GENERAL NOTES SUBSUMMARY
 CALCULATED CJC
 CHECKED CWL
FRA-70/71-12.68/14.86
 69A
 1815

FRA - 70 / 71 - 12.68 / 14.86

RETAINING WALL GENERAL NOTES
 DESIGN AGENCY: **GPD GROUP**
 Class, Pyle, Schaner, Burns & DeLaney, Inc.
 1801 Watermark Drive, Suite 1300, Columbus, Ohio 43215 614-210-0731
 Copyright © Class, Pyle, Schaner, Burns & DeLaney, Inc. 2015
 DATE: 9-6-19
 REVIEWED: T, J, W
 DRAWN: M, O, J
 DESIGNED: D, G, N
 CHECKED: R, H, C
 STRUCTURE FILE NUMBER
 REVISED
 RHC
 FRA-70/71-12.68 / 14.86
 PID No. 105523
 6A / 14
 703A
 1815

1 SCREENWALL LIGHTING SYSTEM
SCALE: 1 1/2" = 1'-0"

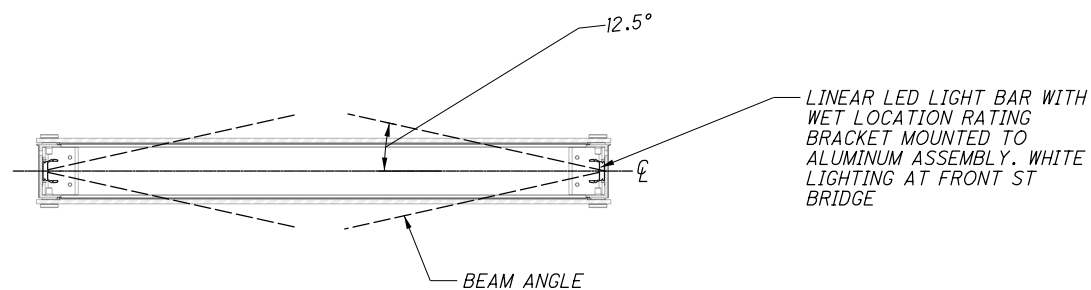
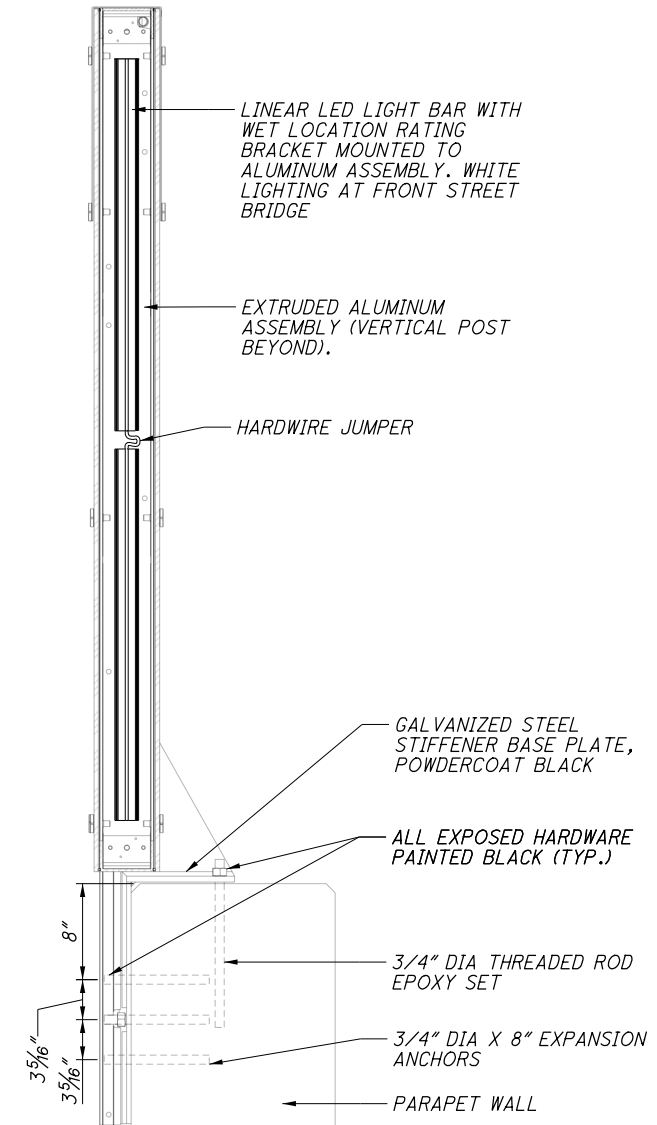
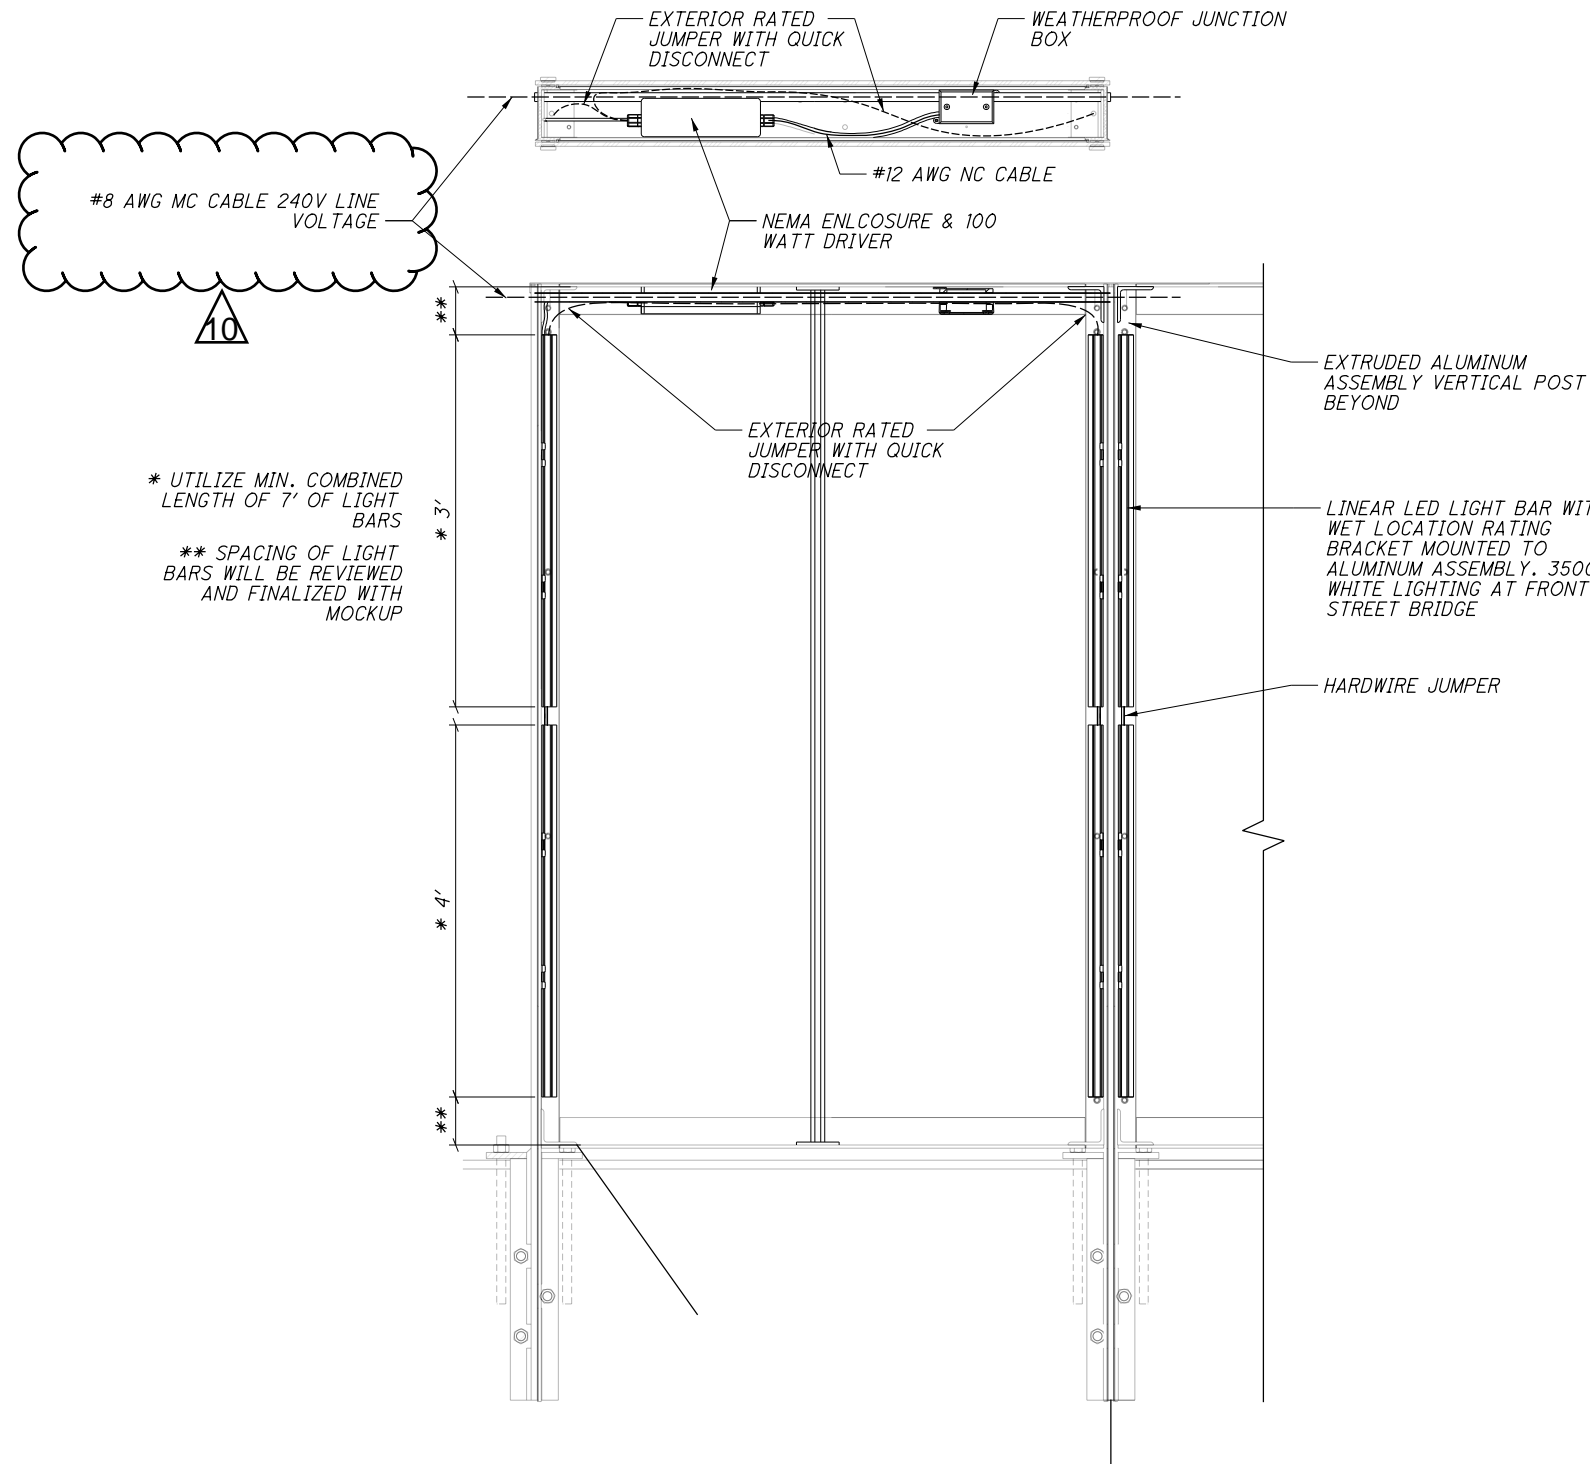
12-13-21: LIGHTED WALL PANEL NOTES AMENDED, DETAIL ADDED

NO.	DESCRIPTION	REV. BY	DATE
10	REVISED WIRE SIZES AND VOLTAGE	MKSK/LHW	12.13.2021

- NOTES:
- POLYMER CONCRETE PULL BOX, 13"x24"x12", BETWEEN TRELLIS STRUCTURES. SPLICE TO 240V FEED FOR TYPE 'L1' LINEAR LUMINAIRES, TO 24V POWER SUPPLY FOR L2 SEAT WALL LIGHT, AND TO REMOTE POWER SUPPLY ON BACK OF TRELLIS FOR L3 LUMINAIRES. SEE DETAIL THIS SHEET.

- CONNECT TO CIRCUIT YD IN STRUCTURE JUNCTION BOX. 240V, 1PH, 3W.
 - PROVIDE JUNCTION BOXES MOUNTED BRIDGE WALL CAP, BELOW EDGE OF LIGHTED WALL PANEL. EXTEND (3) #8 AWG CONDUCTORS FROM JUNCTION BOX TO INTERIOR OF WALL PANEL TO CONNECT TO INTERNAL JUNCTION BOX IN WALL PANEL. POWER TO ADJACENT WALL PANELS TO CONTINUE THROUGH INTEGRATED JUNCTION BOXES AND ROUTED THROUGH WALL PANEL CHANNEL SPACE. SEE DETAIL ON THIS SHEET AND AESTHETIC ENHANCEMENT PLANS FOR ADDITIONAL INFORMATION.

- PROVIDE JUNCTION BOX AT REAR OF L1 RECESSED WALL LIGHTS FOR SPLICING TO LUMINAIRE, AS REQUIRED.
 - PROVIDE POWER SUPPLY, INSIGHT CE-320, FOR TRELLIS LINEAR LED LUMINAIRES, MOUNTED TO REAR OF TRELLIS. CONNECT TO CIRCUIT FROM PULL BOX, AND PROVIDE CONNECTION FROM POWER SUPPLY TO LUMINAIRES. EACH TRELLIS WILL HAVE FOUR (4) L3 LUMINAIRES: TWO (2) 36" IN LENGTH, AND TWO (2) 48" IN LENGTH. SEE AESTHETIC ENHANCEMENT PLANS FOR FURTHER INFORMATION.
